INNER WEST COUNCIL

DEVELOPMENT ASSESSMENT REPORT

Application No.	D/2018/490
Address	168 Norton Street, LEICHHARDT NSW 2040
Proposal	Demolition of all structures on site. Site remediation, construction of a 5 storey building to provide residential accommodation for seniors and associated community use at ground level, plus a new retail shop fronting Norton Street at ground floor level with two levels of basement car parking are proposed providing parking for 57 vehicles at 168 Norton Street, Leichhardt.
Date of Lodgement	13 September 2018
Applicant	Uniting
Owner	The Uniting Church In Australia Property Trust NSW
Number of Submissions	21
Value of works	\$16,920,000
Reason for determination at Planning Panel	Planning Agreement / SEPP 65 (4 Storeys or higher) / Number of submissions / subject to a Voluntary Planning Agreement
Main Issues	Vehicular access Waste management Heritage impacts Visual and acoustic privacy
Recommendation	Deferred Commencement Approval

Figure 1: non-compliance with built form control on the eastern elevation. (shown in white exceeding the blue building envelope)

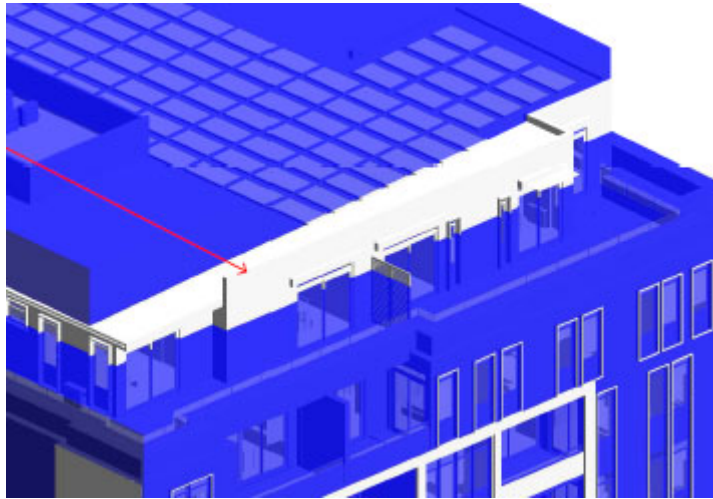
The proposal includes a non-compliance with G9.6.1 C1 and C2 in that the setback of the fifth storey is less than 6m with a setback of 3.8m.

Figure 2: Non-compliance with built form control on the northern elevation. (shown in white exceeding the blue building envelope)

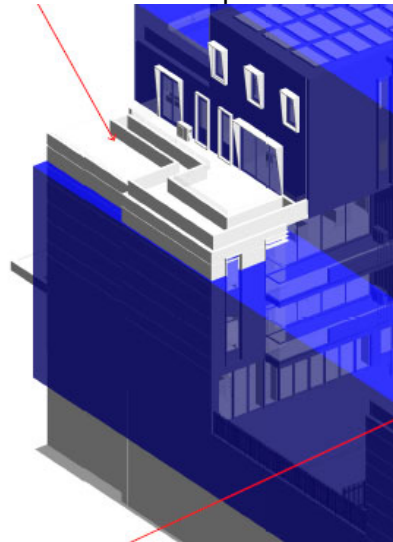
The proposal includes a non-compliance with G9.6.1 C1 and C5 in that the height on the northern boundary in part RL 41.9 whereas the control requires RL 40.40. This noncompliance is limited to the section of the development as indicated in the below image.

Figure 3: Non-compliance with built form control on the stairwell. (shown in white exceeding the blue building envelope)

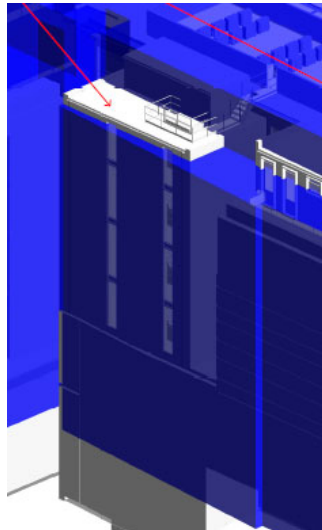
The proposal also includes a small non-compliance with G9.6.1 C1 related to the height of the stairwell. This non-compliance is obscured behind the adjoining shops to the south east of the site. This is noncompliance is indicated in the below image.

Figure 4: Non-compliance with rear lane setback. (shown in white exceeding the blue building envelope)

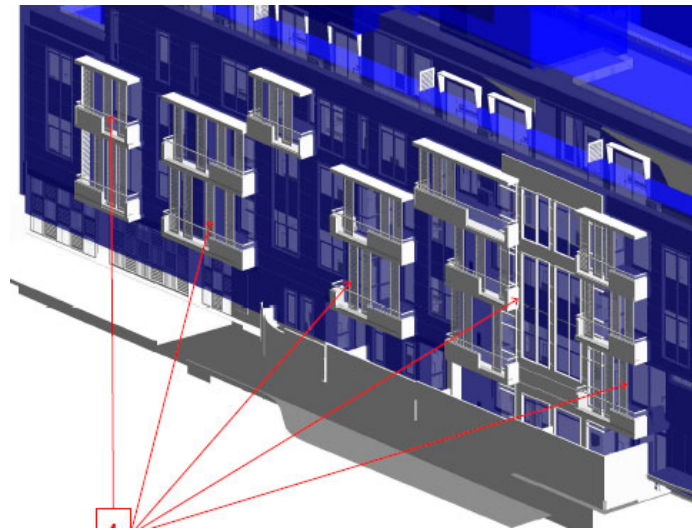
The proposed development is largely consistent with the setback controls contained within G 9.6.2, however, the following non-compliances exist in relation to the setback of the fifth floor setback from Norton Street (C6) and the 3rd floor not being setback 6m from the northern boundary (C13). The balconies off the rear lane are within the 3m setback and part of apartments encroach on the rear lane setback for 0.3m as shown below:

Figure 5: Non-compliance with rear lane setback. (shown in white exceeding the blue building envelope)

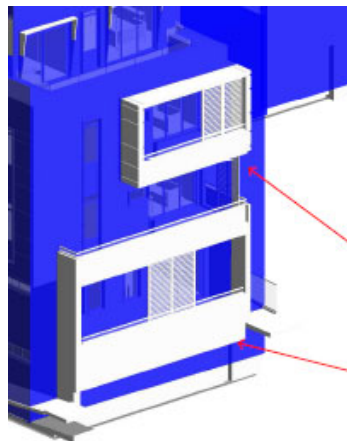
The proposal also has non-compliances in relation to the Carlisle Street setback (C8).as shown below:

Figure 6: Screening of the communal terrace on the northern side.

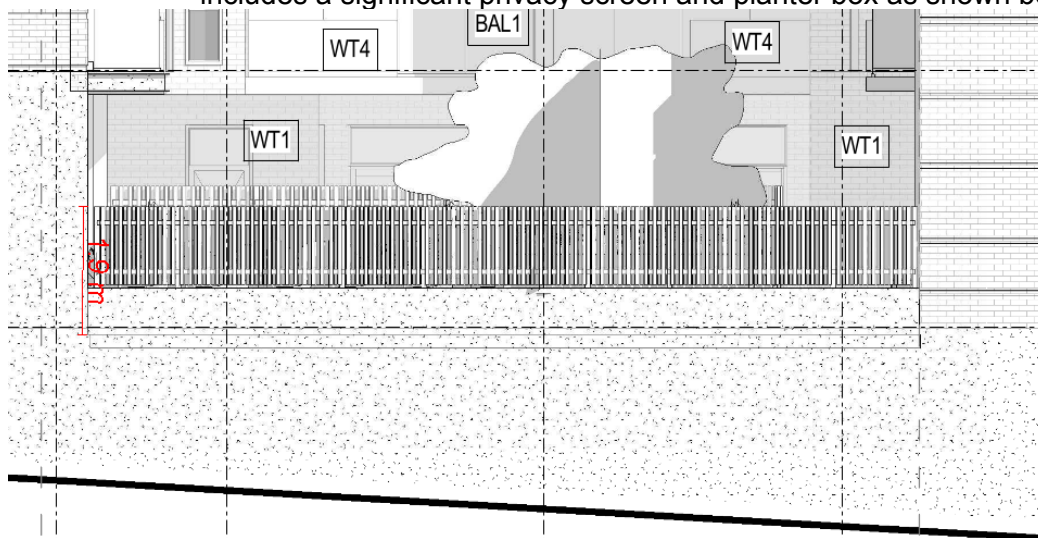
Issue: Visual privacy to 2, 4, 6 and 8 Macaulay Street.

Comment: As addressed within C3.11 subject to the recommended conditions of consent the proposal is considered to have acceptable impacts on visual privacy noting that separation via distance as referred to within *Meriton v Sydney City Council* [2004] NSWLEC 313. With reference to the courtyard the proposal includes a significant privacy screen and planter box as shown below:

Figure 7: Privacy issue with balcony of apartment R4-06.

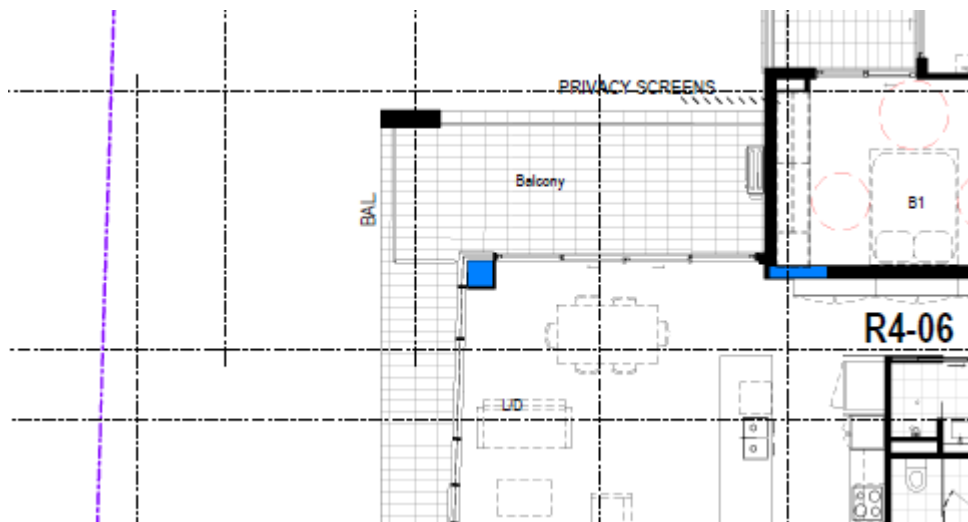
With regard to the balconies on the northern side on the development, separation has been achieved via distance, planter boxes and setback balustrades for all balconies with the exception of the level 4 balcony off apartment R4-06. As shown below:

A condition of consent is recommended setting back the balustrade on the northern side to be in line with the edged of the living room. This will provide a horizontal privacy screen to the adjoining properties. It is noted that the apartment above this on level 5 maintains a setback that is acceptable.
